MIDLAND PROJECT -
ALAB-106 MONTHLY REPORT FOR NOVEMBER 1980
DOCKET NOS 50-329 AND 50-330
FILE: 0.4.6 UFI: 70*01 SERIAL: 10088

In accordance with Condition of Memorandum and Order ALAB-106, dated March 26, 1973, and Amendment No 1 of the Midland Plant Construction Permit, enclosed are ten copies of the following documents written or closed during the month: Bechtel Nonconformance Reports, sheets from the Bechtel Nonconformance Report Log; Bechtel Quality Action Requests; Babcock & Wilcox Reports of Nonconformity; B&W ISI NCR's; and Consumers Power Company Nonconformance Reports, Audit Finding Reports, Quality Action Requests, and Corrective Action Reports.

LOG OF NONCONFORMANCE REPORTS

NCR# 1750

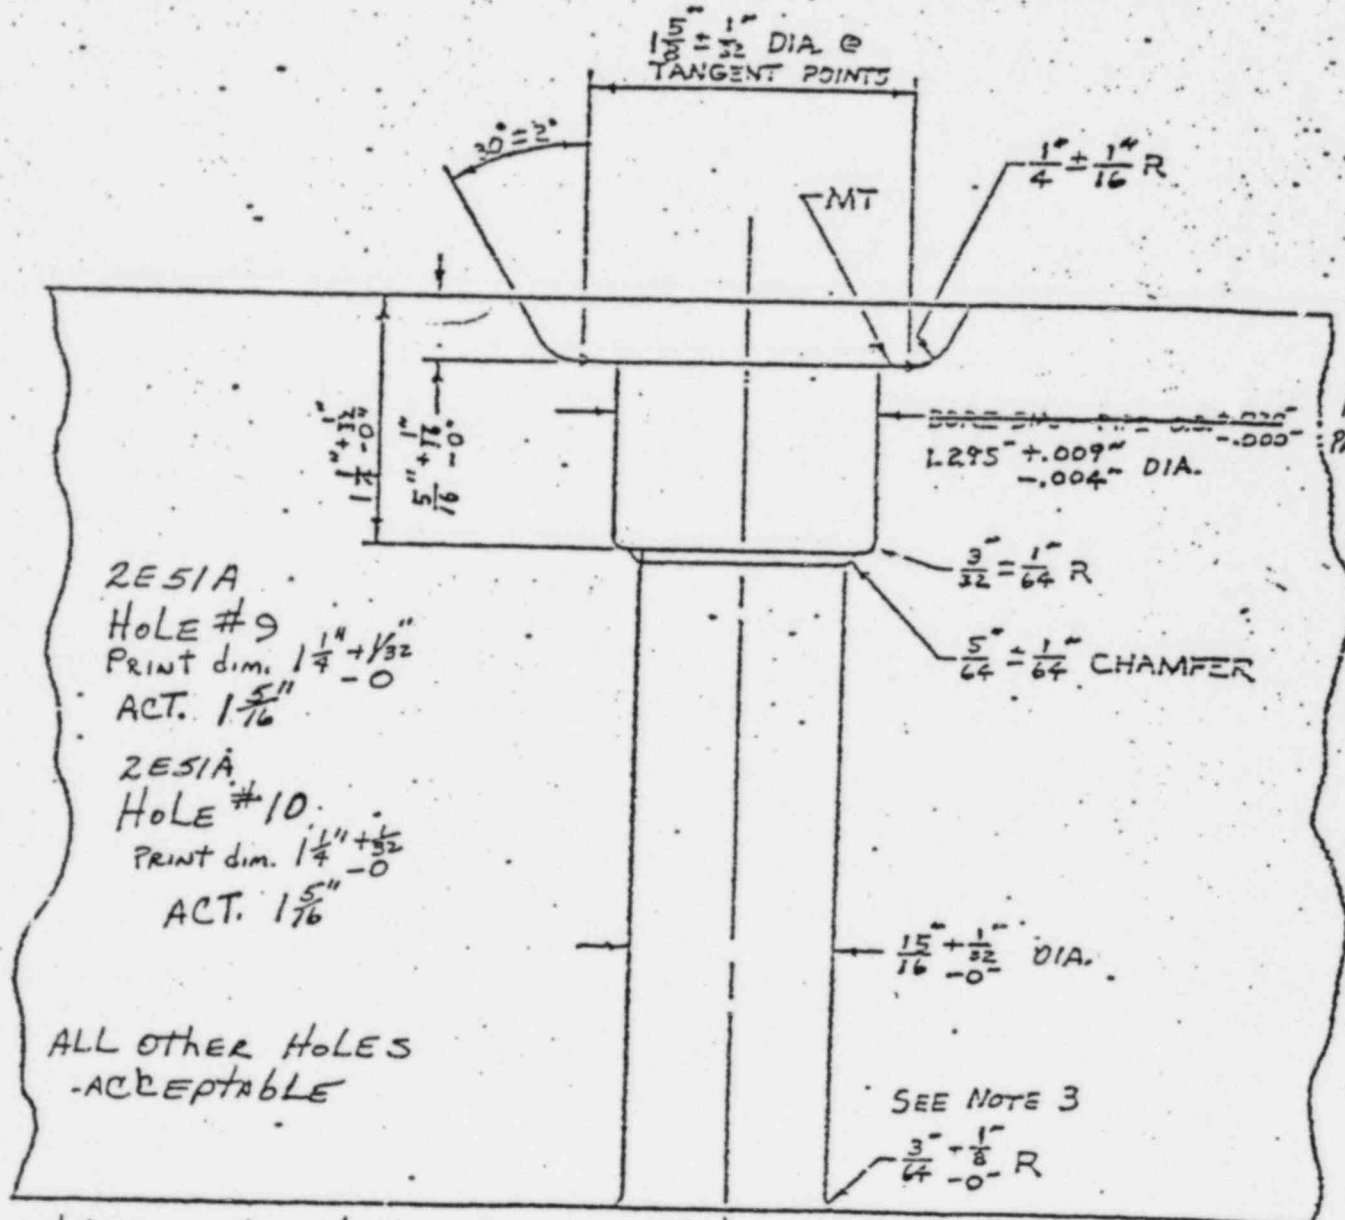
13. DESCRIPTION OF NONCONFORMITY 1. The machined finish of the penetrations in 2E51A(north Gen.) and 2E51B(south Gen.) do not meet 250/RHR required in FCA #47. The finish is 500/RHR. 2. Three of the penetrations, #7, #9, & #10 in 2E51A(north Gen.) exceed tolerance of dimensions. See sheet 2 of 2.

25. CORRECTIVE ACTION The tooling has been redesigned. An instruction program for craft personnel will be given with a mock-up of the Steam Generator. <u>Walter J. ...</u> FIELD PROJECT MANAGER DATE 9/30/80
